FIELD SERVICE CAMPAIGN – 25101

Trans/Air Evaporator Temperature Sensor Location Correction

IC Bus™ Electric CE Series buses

Figure 1. Evaporator Temperature Sensor Location

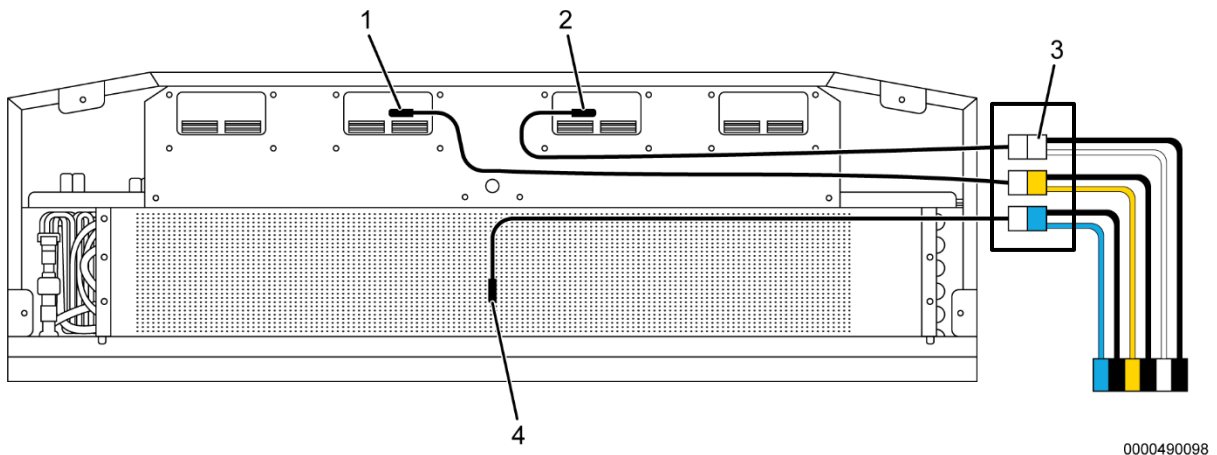
Certain IC Bus™ Electric CE Series buses may have the front and rear A/C evaporator temperature sensor harness routed incorrectly.

7. Gain access to evaporator.
8. Gain access to wire color temperature sensor connectors.
9. Inspect all temperature sensor connectors for correct wire color connections.

NOTE: The labeling for the sensors on the harness will be incorrect. Please disregard any of the harness labeling.

1. Coil temperature – YELLOW wire connector
 2. Outlet temperature – WHITE wire connector
 3. Three temperature sensor connectors with two wire color identification
 4. Return temperature – BLUE wire connector
10. Connect temperature sensors to correct color wire based on location of sensor, referring to Figure 1.
 11. Connect YELLOW wire to coil temperature sensor (Figure 1, Item 1).

12. Connect WHITE wire to outlet temperature sensor (Figure 1, Item 2).
13. Connect BLUE wire to return temperature sensor (Figure 1, Item 4).
14. Follow Steps 7–13 to complete rear sensor swap.
15. Verify A/C operation, ensuring A/C system does not short cycle and cools properly.
16. Remove wheel chocks.
